DEVELOPMENT REVIEW BOARD

Parks and Recreation Department

PR-2021-006258
PS-2021-00139 – SKETCH PLAT
CSI – CARTESIAN SURVEYS, INC. agent for BRUNACINI DEVELOPMENT LTD. Co. requests the aforementioned action(s) for all or a portion of: TRACTS A-2-A and A-3-A, UNIT 2, JOURNAL CENTER PHASE 2 zoned NR-BP, located on RUTLEDGE between, BARTLETT ST NE and NORTH DIVERSION CHANNEL containing approximately 4.7453 acre(s). (D-16)
PROPERTY OWNERS: BRUNACINI DEVELOPMENT, LTD.CO
REQUEST: LOT LINE ELIMINATION

PR-2021-006258
SI-2022-00057 – SITE PLAN
TIERRA WEST, LLC agent for BRUNACINI DEVELOPMENT LTD CO requests the aforementioned action(s) for all or a portion of: TRA-1-A A-2 A, JOURNAL CENTER PHASE 2, UNIT 2 zoned NR-BP, located on RUTLEDGE ST NE between RUTLEDGE RD NE and BARTLETT ST NE containing approximately 4.7483 acre(s). (D-16, D-17)
PROPERTY OWNERS: BRUNACINI DEVELOPMENT LTD CO
REQUEST: DRB SITE PLAN

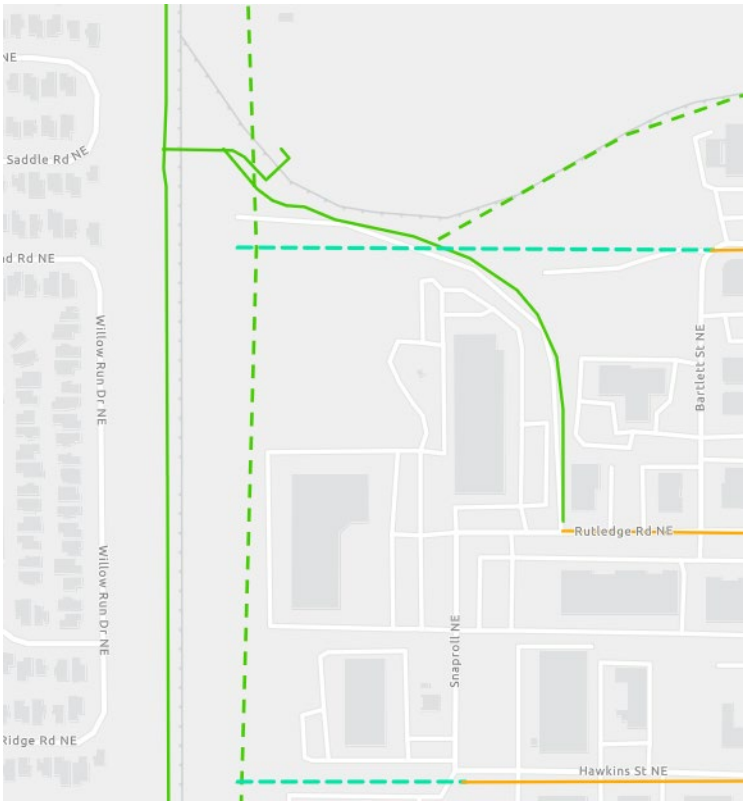
- The MRCOG Long Range Bikeway Map shows a proposed multi-purpose trail on this side of the AMAFCA ROW (see screen clip below). This may need to be added to the required infrastructure on the west side of the property.

- Given the updated MRMPO LRBS showing a proposed multi-use trail along the east side of the North Diversion Channel (shown above), ~~PRD desires to plan in accordance since a multi-use trail is a desirable recreational amenity in the area.~~ Through discussions with DMD, Transportation, and AMAFCA, PRD scheduled development of the trail project. The proposed multi-use trail is in lieu of a bike-lane and sidewalk originally designed for the proposed Channel Road in this location, and the driving lanes of Channel Road could proceed in the future if funding becomes available through DMD. It is expected that the proposed multi-use trail will be part of an Infrastructure List for this project and as part of a Procedure C agreement, funds will be held ~~in a PRD account~~, ~~and put~~ toward a larger trail project.
